ADDENDUM C

NORTH PARK MINI PARK

BID NO.:	<u>K-20-1864-DBB-3</u>
SAP NO. (WBS/IO/CC):	<u>S-10050</u>
CLIENT DEPARTMENT:	<u>1714</u>
COUNCIL DISTRICT:	<u>3</u>
PROJECT TYPE:	<u>GC</u>

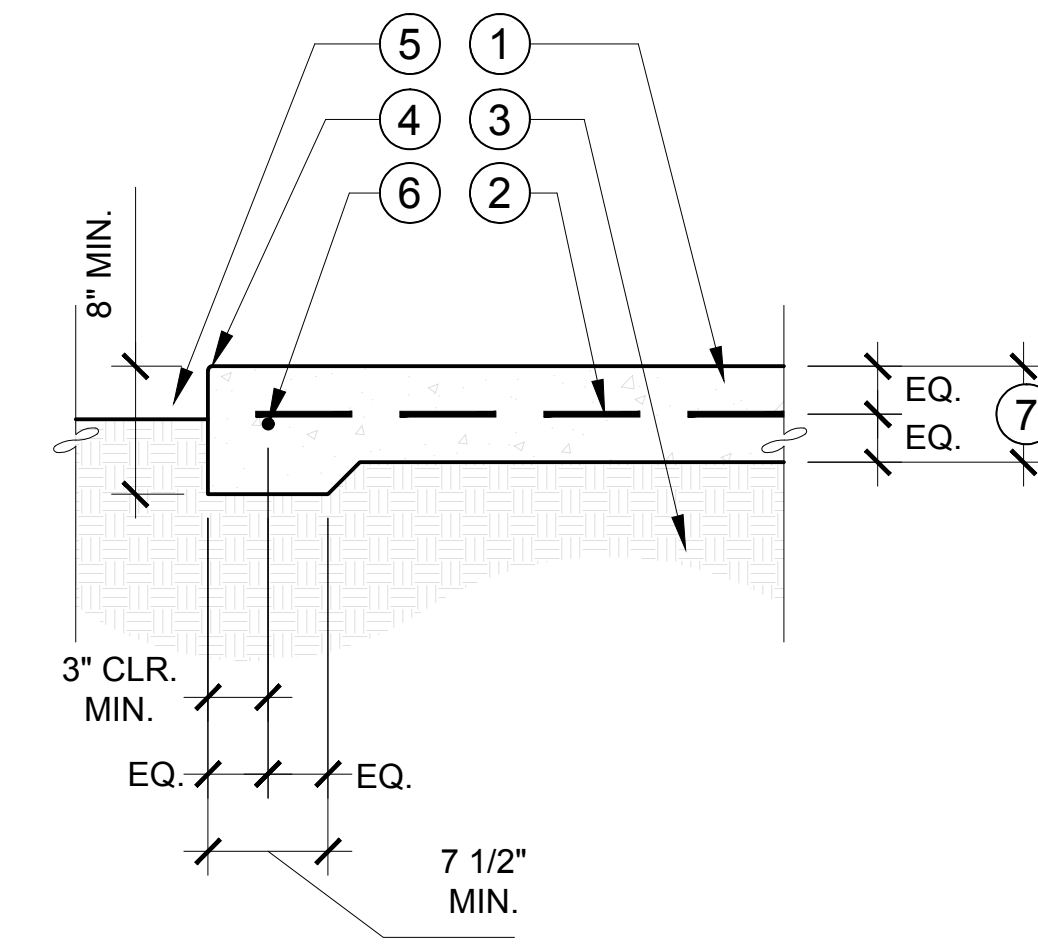
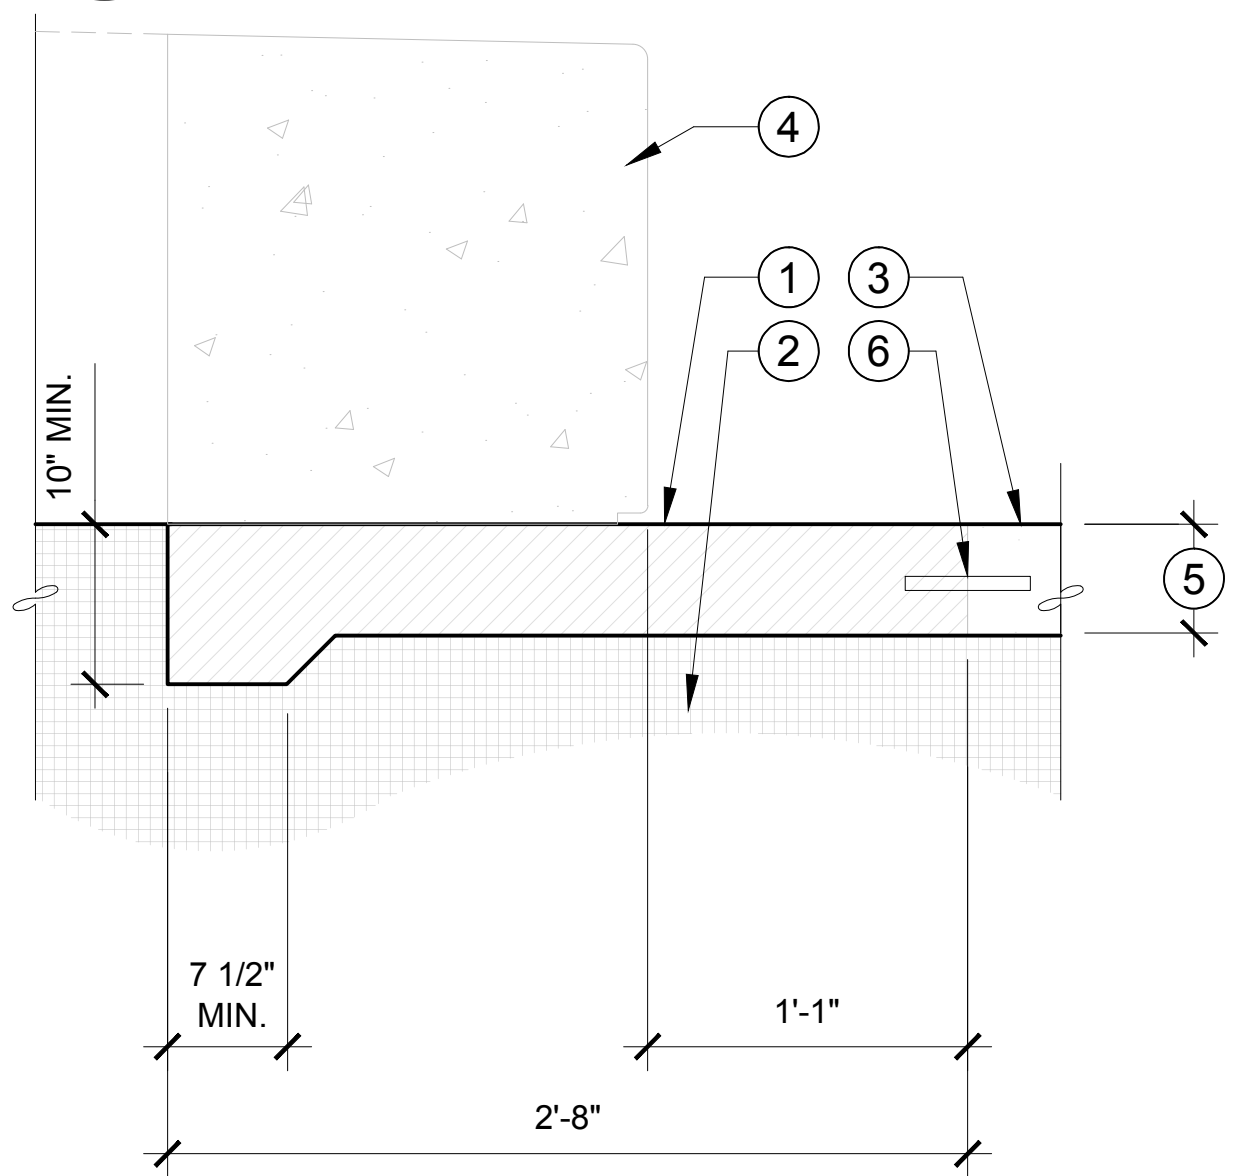
STORAGE CONTAINERS REMOVED.

1 DRINKING FOUNTAIN SECTION

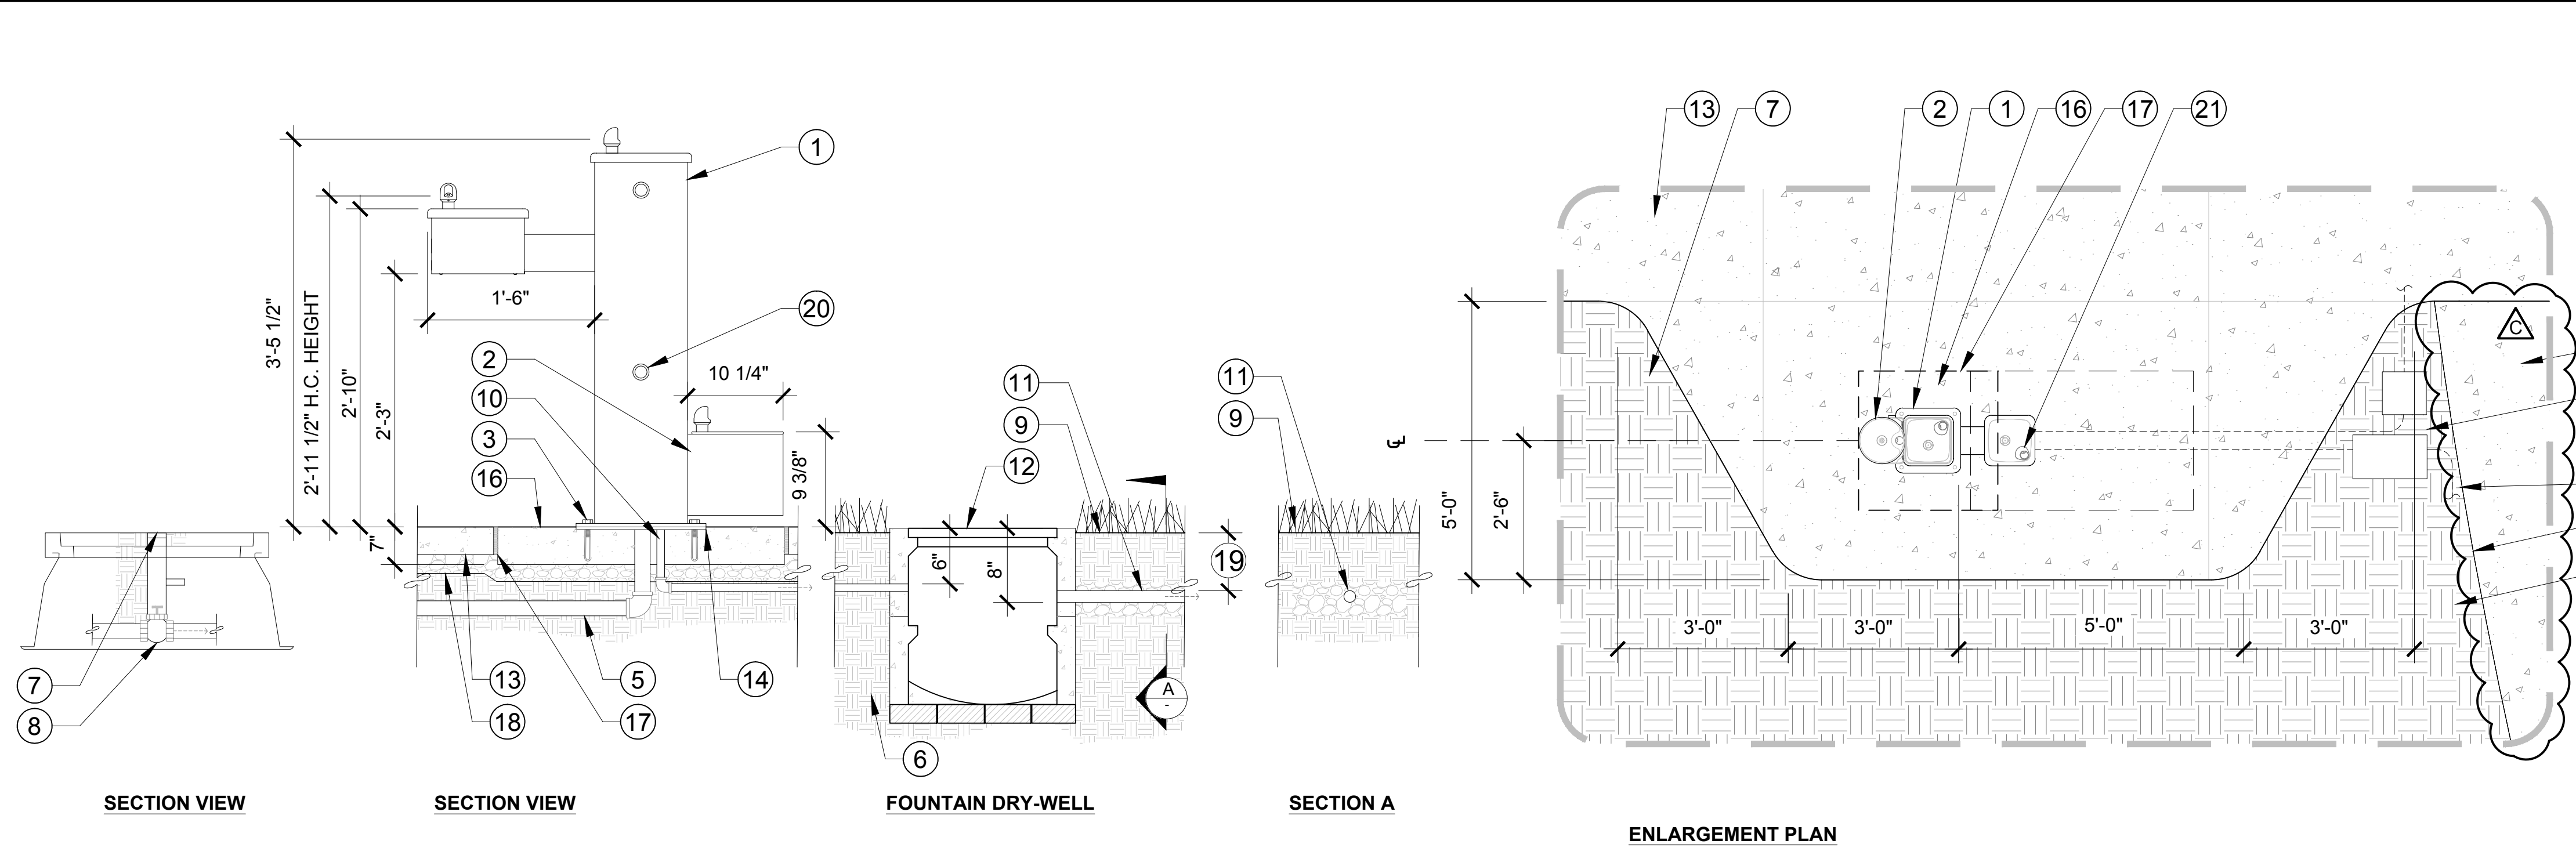
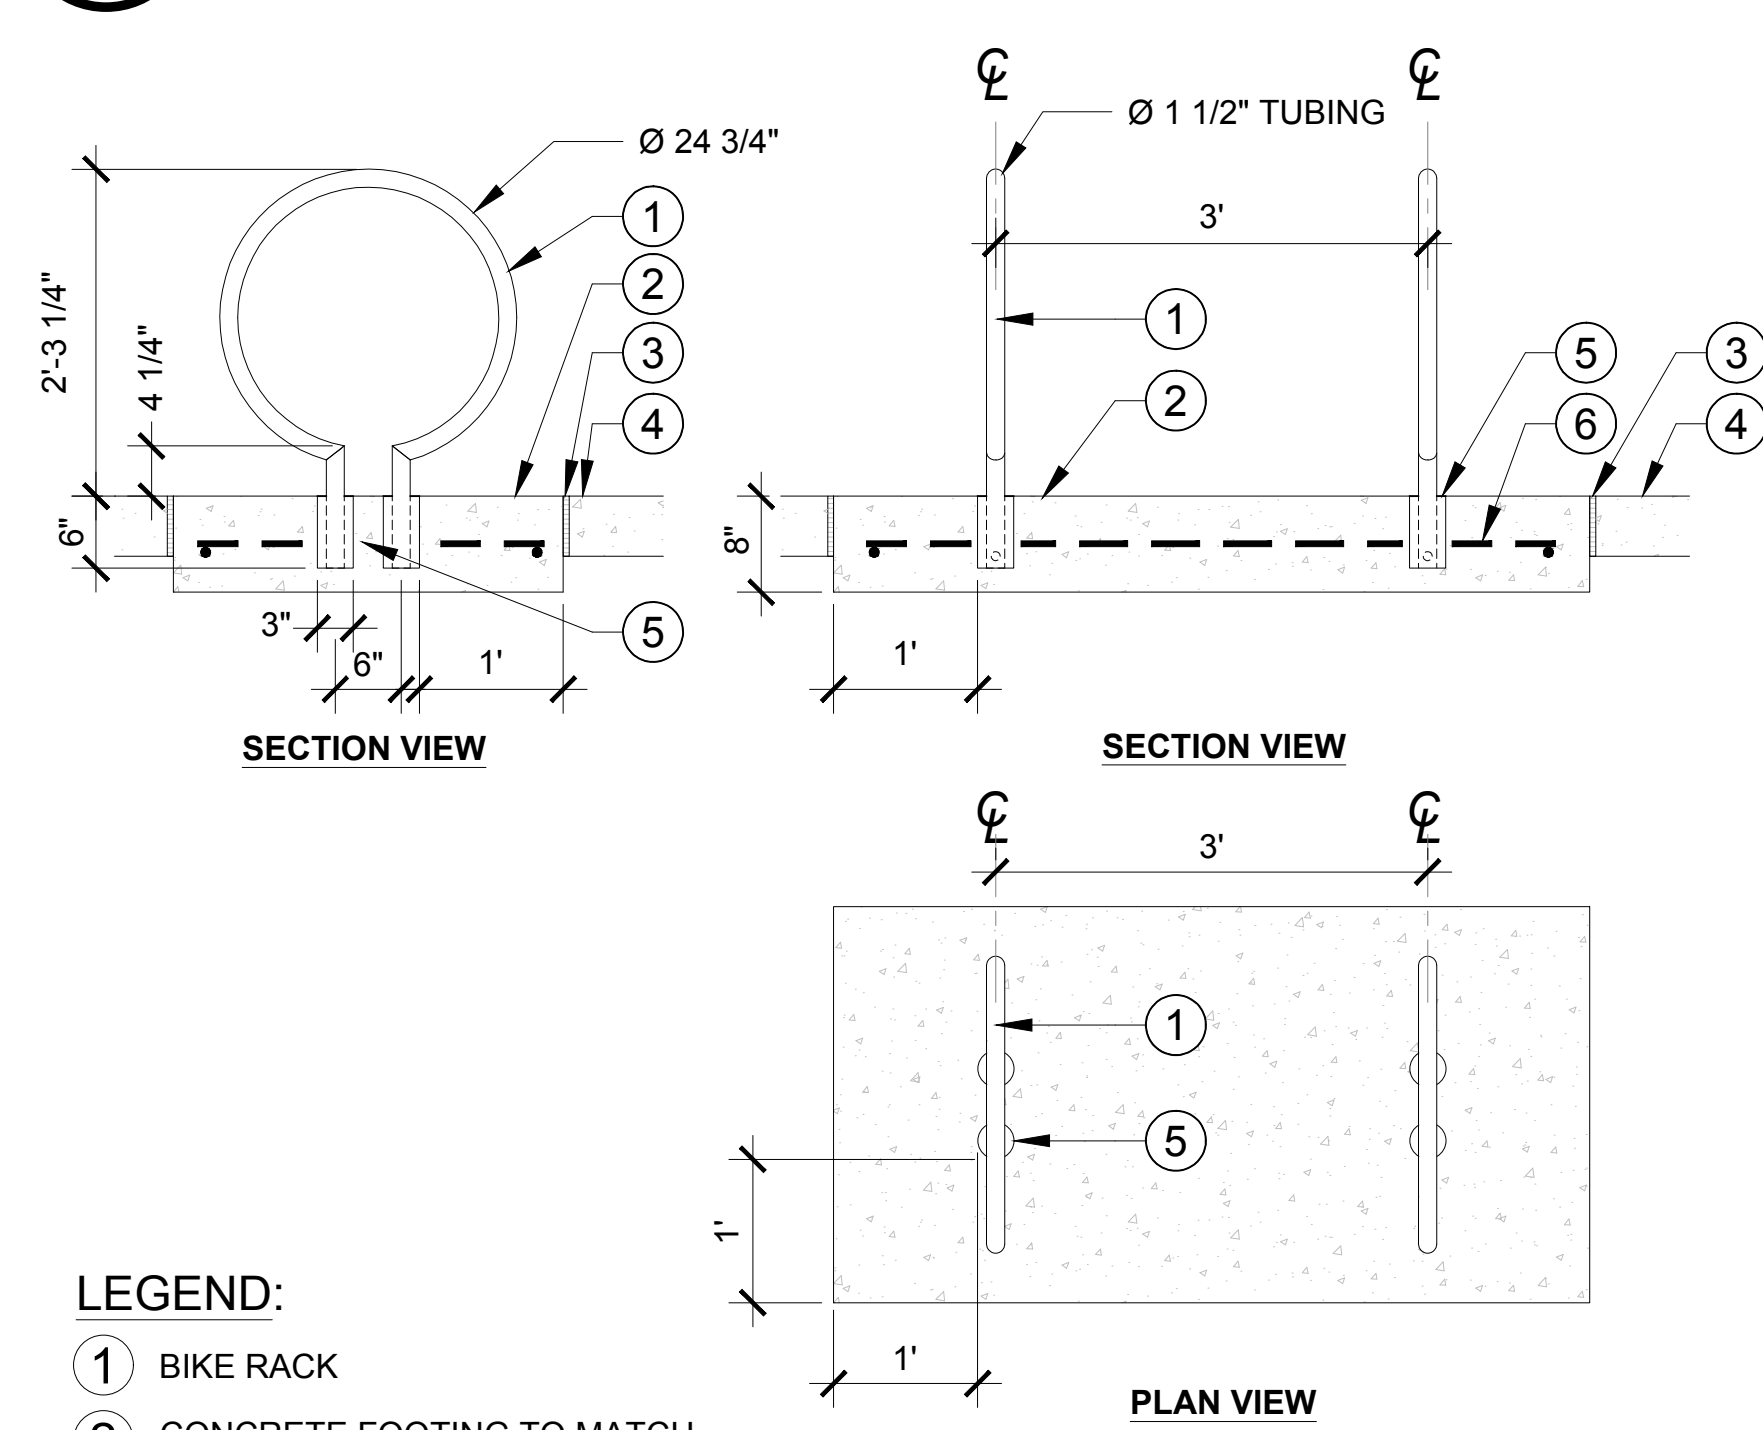
DETAIL REVISED. DG CHANGED TO CONCRETE.
